BMA Caval Ridge Mine Project

Change Request Accommodation Location and Capacity

September 2010

Figure 1: Village Location

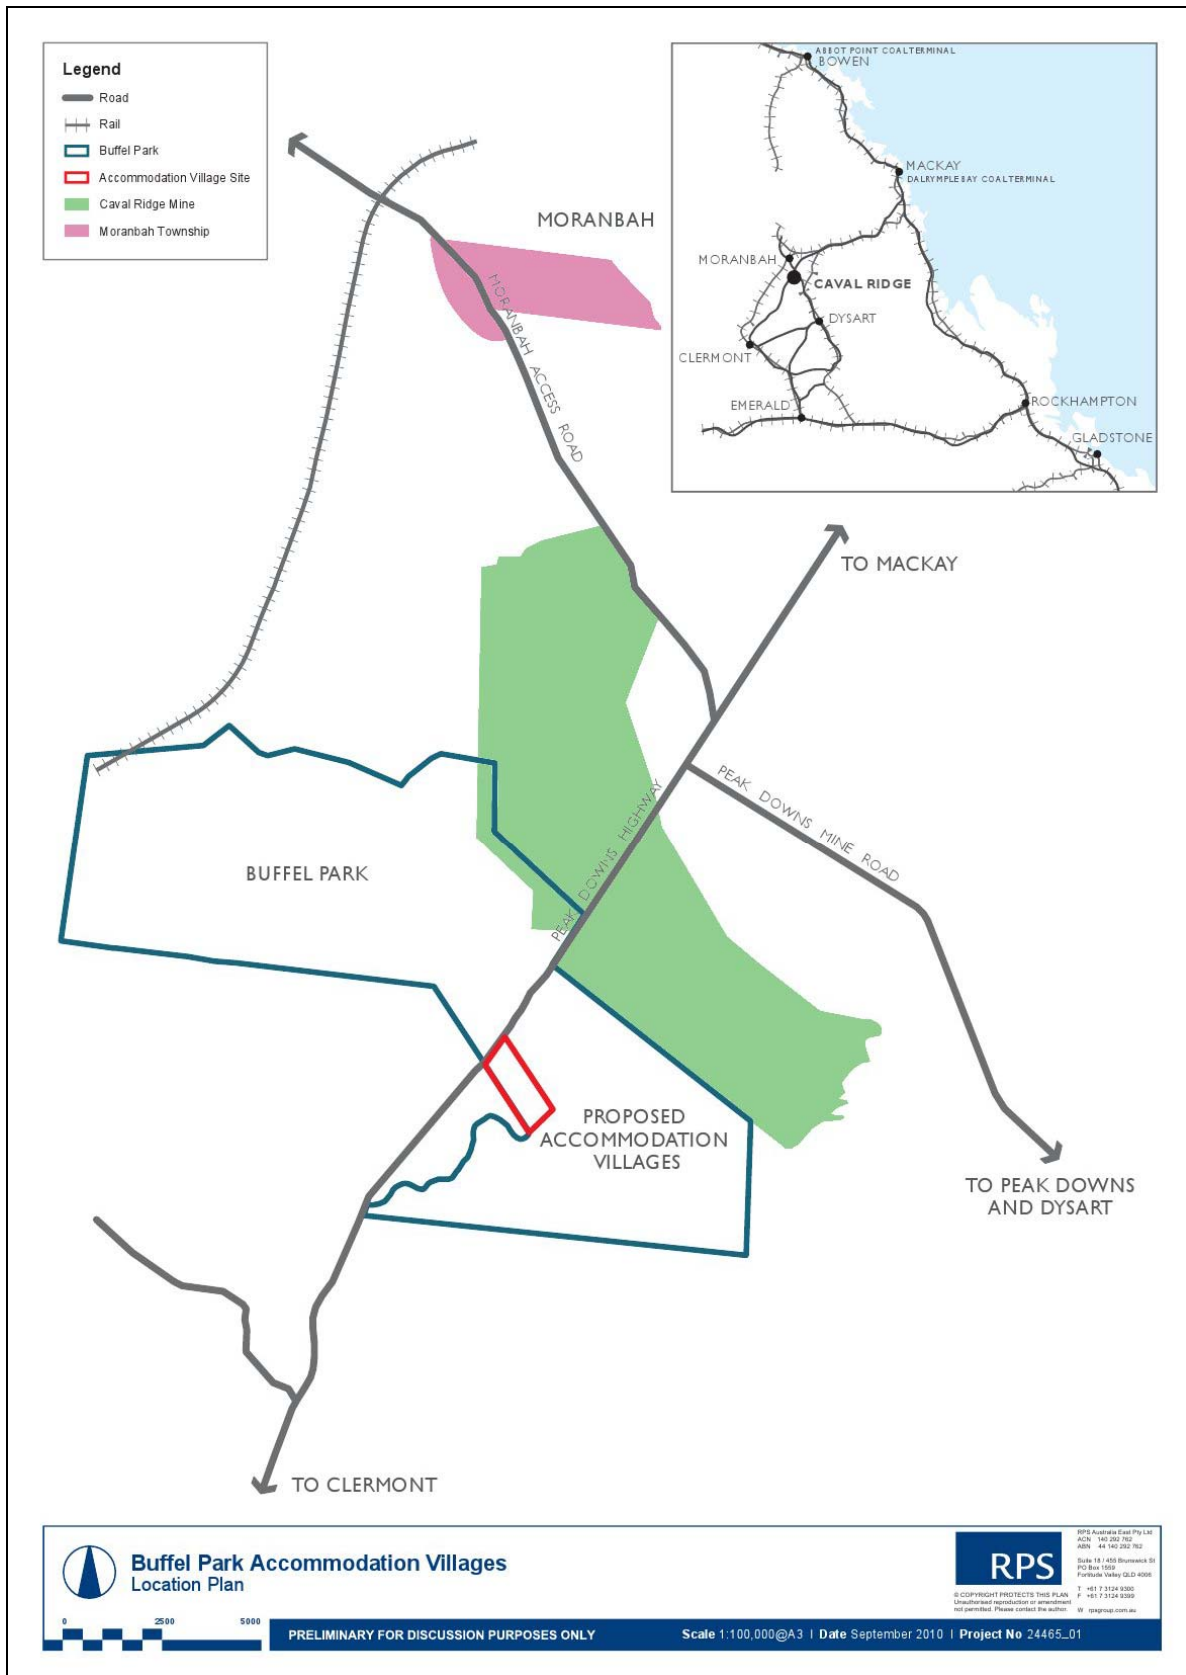
The location of Buffel Village is shown as Figure 1.

The specific location of the proposed Buffel Village is on the south-eastern side of Peak Downs Highway to the south of the proposed CRM. The location and extent of the Buffel Village footprint is shown as Figure 1.

Figure 2: Village Layout

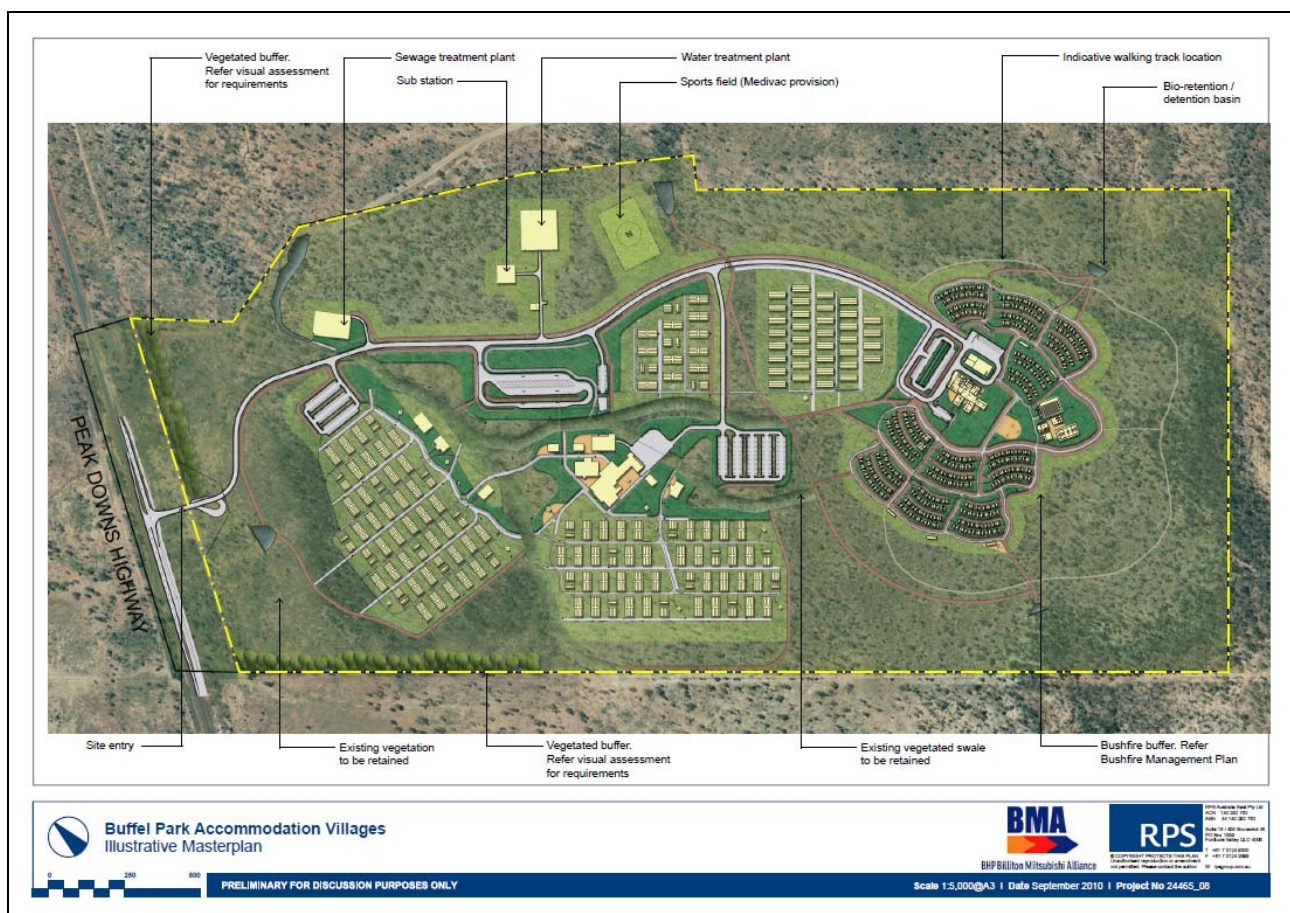
The Accommodation Villages Masterplan Structure (RPS Drawing 24465_09 dated September 2010), illustrated as Figure 2 and contained in Appendix C to the DA, illustrates the overall pattern of development, showing:

- The access and service road extending from the Peak Downs Highway into the site;
- The common infrastructure and services area located to the north of the service road;
- The Construction Village, including its core facilities as the western portion of the development footprint;
- The Operations Village, including its core facilities as the eastern portion of the development footprint; and
- Bushland and open space around the periphery of the site providing a landscape buffer, including areas where revegetation is proposed to minimise the visual impacts of the development and provide opportunities for active and passive recreation.
